AERONAUTICAL CHARTING FORUM
Instrument Procedures Group
April 24, 2013
HISTORY RECORD

FAA Control # 13-01-309

Subject: LP Procedure Cancelled Because of VDA Not Being Charted

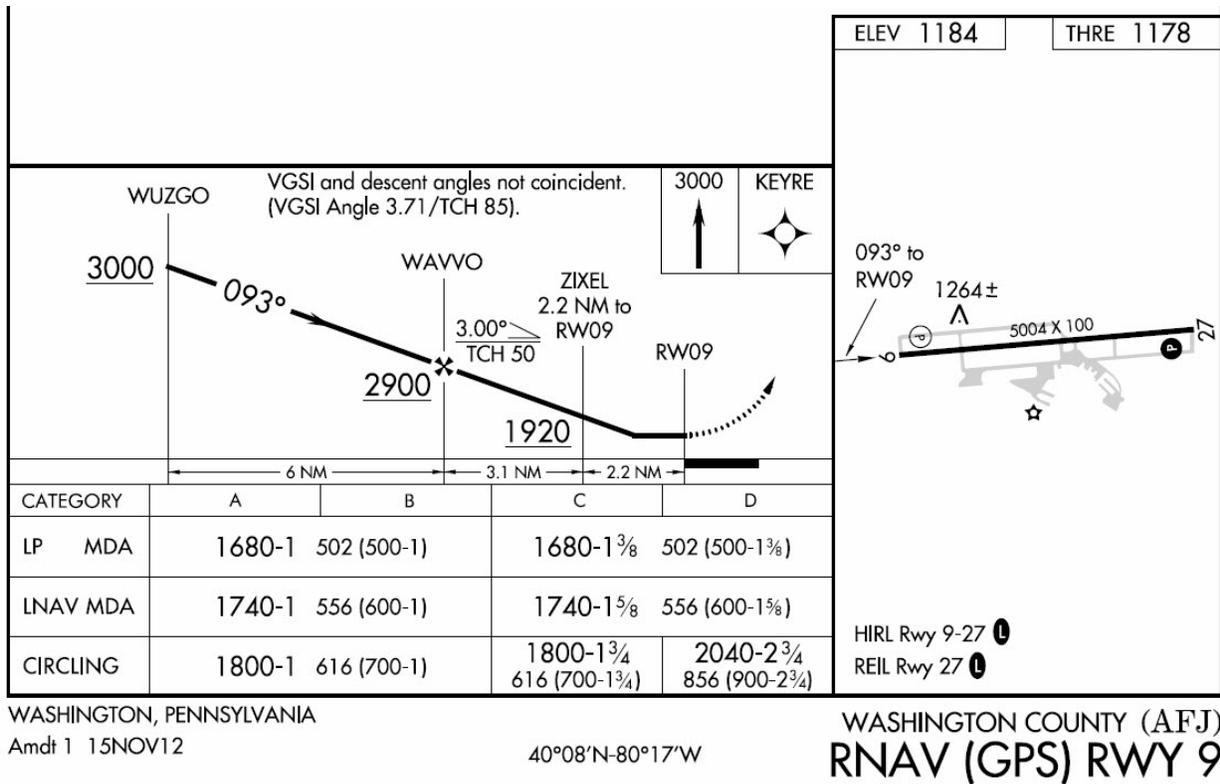
Attached is the back of the 8260-9. Could you point me to the reason for the deletion of LP?
I cannot find it.

I have several issues with this. The purpose for LP procedures is to provide a lower MDA than permitted by the LNAV where the smaller OCS footprint allows. It is only used when a vertically guided procedure isn't appropriate for the runway. Although a Constant Angle Non Precision Approach (CANPA) may be desirable, it is not always available as an option on all NPA procedures. The advisory glidepath provided by some manufacturers' GPS units is only permitted to be used during the descent to the MDA and not below it. It is my understanding that regardless whether a VDA is published or not, advisory vertical guidance may be provided, in that if the 8260 doesn't provide the data for the advisory glidepath, the manufacturer may calculate one. Therefore, setting the VDA to 0 in the database doesn't necessarily eliminate the advisory glidepath from the database. Because of the coding issue described by the Quality Advisor, the LP procedure is eliminated. It is ironic that the unintended consequence is that the LNAV will end up with an advisory glidepath, but if it is coded in the database it will not generate advisory guidance, at least in the Garmin units. This is because, the LP procedure in the Garmin units don't support advisory vertical guidance under any circumstance whenever LP is the highest service level coded for the approach, regardless if the integrity at the time of the approach supports LP or LNAV. My understanding of the ACF issue dealing with VDA was only to affect whether or not the VDA would appear on the chart and there was to be a note added to the effect "Descent Angle NA". This situation ends up being a 'catch 22', if the runway doesn't qualify for vertical guidance, and flight testing indicates that CANPA is not an option, it doesn't qualify for LP, and when a LP is coded it doesn't have advisory vertical guidance, but if only a LNAV is coded, it does have advisory vertical guidance.

Recommendations: The database coding of LP procedures should be permitted even when the VDA is not charted. Being able to fly a procedure with CANPA should not be a requirement for a NPA.

This is the reason, but it has more to do with coding. Once we remove the VDA, the coding has to be changed 3.00 degrees to 0.00 degrees thus negating the LP minimums and the FAS DATA. If we kept the 3.00 degrees in coding it would override what we are trying to prevent. We are trying to prevent the aircraft flying from FAF to THLD, like an LPV /ILS, when it should be flying from FAF to MDA like an LNAV.

We had a test case go thru flight inspection to see if we could keep LP minimums, but it did not work. I hope this answers your question.
